Subject: Amended MHI's Responses to US-APWR DCD RAI No. 728 COLP-4534 REVISION 2 (SRP 18)

Amended Responses to Request for Additional Information No. 728
COLP-4534 REVISION 2

**US-APWR Design Certification
Mitsubishi Heavy Industries
Docket No. 52-021**

RAI NO.: NO. 728-4534 REVISION 2
SRP SECTION: 18.1 - HUMAN FACTORS ENGINEERING
APPLICATION SECTION: 18.01 – 18.1 PROGRAM PLAN
DATE OF RAI ISSUE: 04/04/2011

Figure 1 HFE Team Project Organization

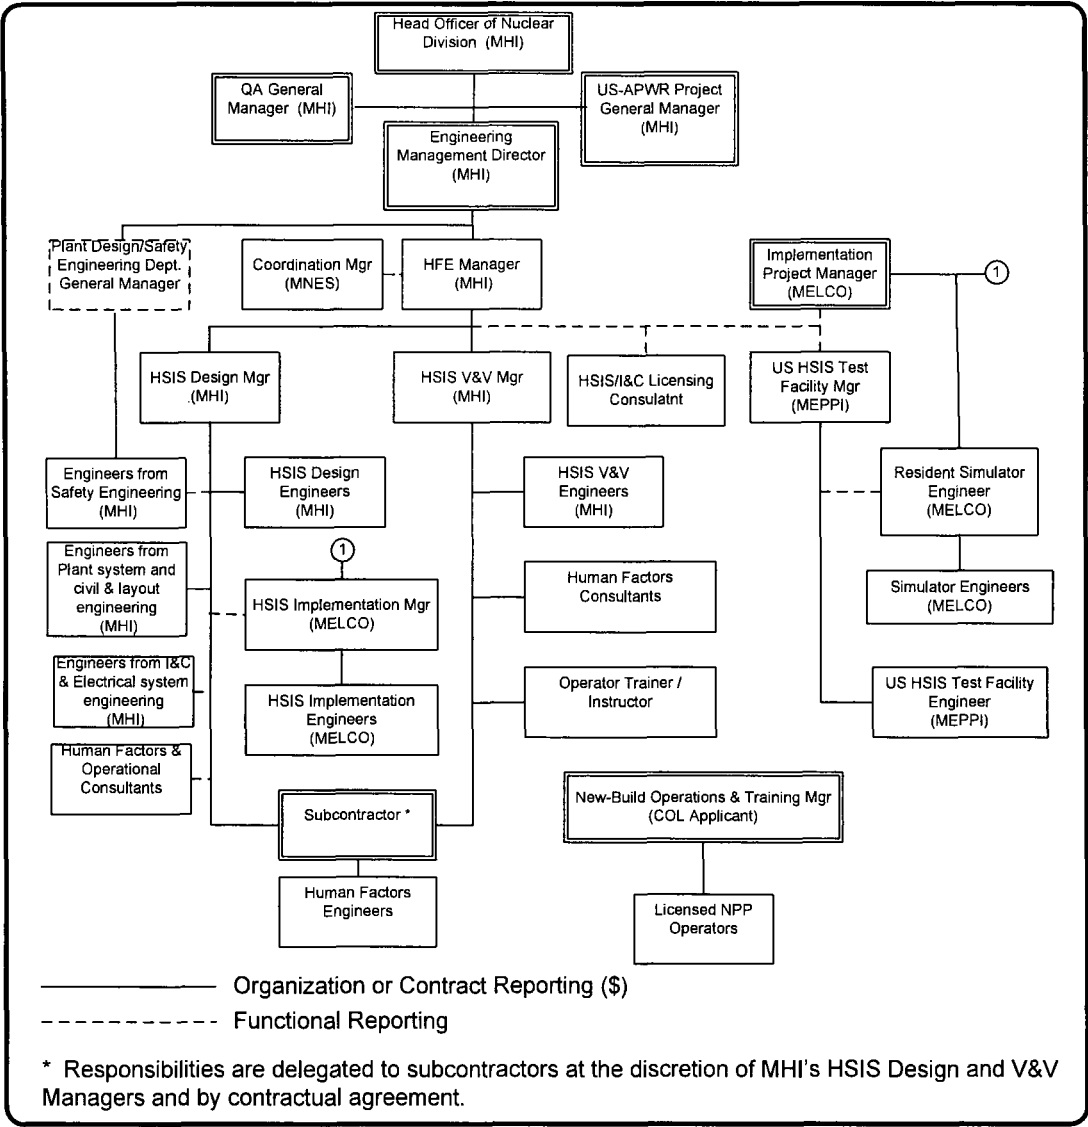
The diagram in DCD Figure 18.1-1 does not show how the HFE design team fits into the larger design team and the US-APWR project.

MUAP-09019, Section 3.2, Figure 1 provides an organization chart which includes both organizational and functional relationships but only shows the organization up through project manager positions. It is unclear how they fit in the larger engineering organization. RAI 295-2341, Question 18-9 requested this information. The response (UAP-HF-09225) stated the organization placement and authority of these teams is controlled by the "Quality Assurance Program . . . (PQD-HD-19005)." This document shows the high level organization but does not connect that organization with the organization described in MUAP-09019.

- Describe the management levels between the project manager described in MUAP-09019, Figure 1 and the management position described in the QA program.
- Include or reference within the DCD the information in MUAP-09019 and this RAI response so more detailed organizational information is available to illustrate how this criterion is met.

Figure 1 of MUAP-01019 will be revised as per shown in Attachment 1, showing the HFE team organization in the MHI engineering and design organizations.

DCD Figure 18.1-1 will be replaced with Figure 1 in MUAP-09019 Part 1 to clarify the organization.

Figure 3 Engineering work process and integrations flow between HFE team and plant design organizations

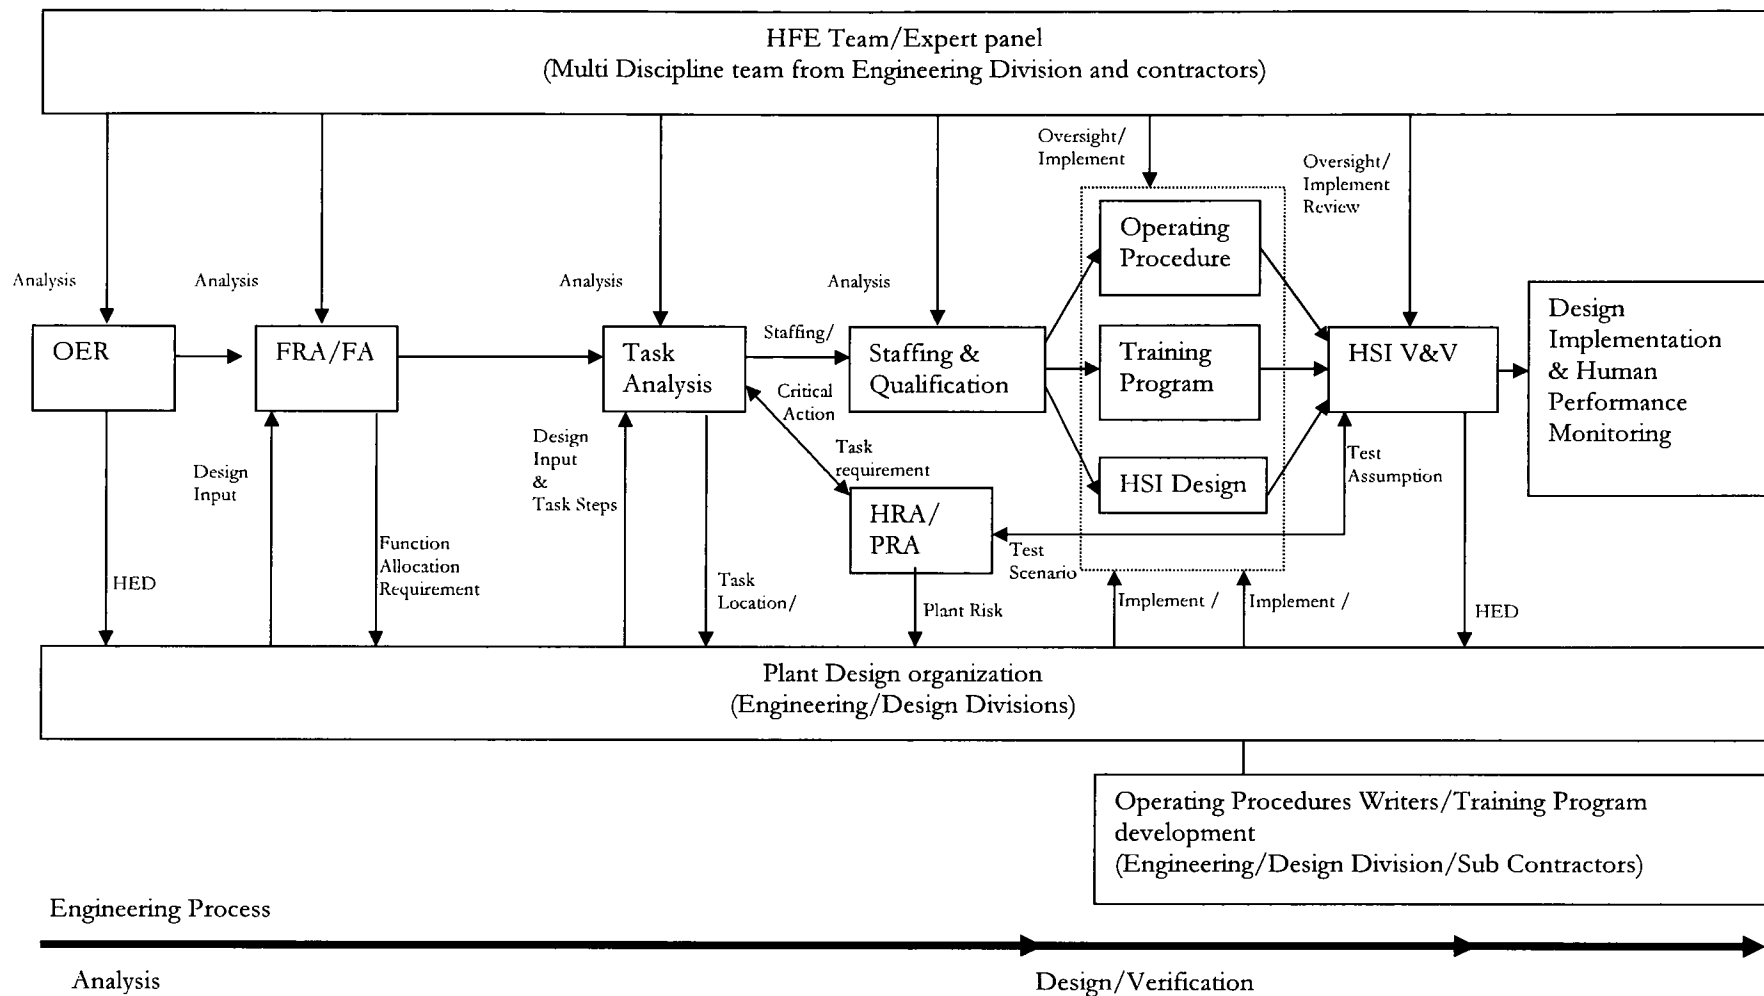
- Provide the title of working level procedures that control work flow, work priority, work review, describe interfaces with project management, and describe interfaces with supporting technical groups.
- List the key data bases, forms, and other tools contained in these procedures that are used to facilitate proper implementation of the procedure.
- Provide a flow chart of the engineering process that includes process feedback, issue disposition, independent reviews, and supporting technical reviews.

Figure 2 shows the HFE milestone and critical checkpoint embedded in the plant design, procurement, constructions and operation. Figure 3 show engineering work processes and integrations with plant design organizations. Arrows show critical checkpoints which indicate each activities milestones and relations with other HFE elements.
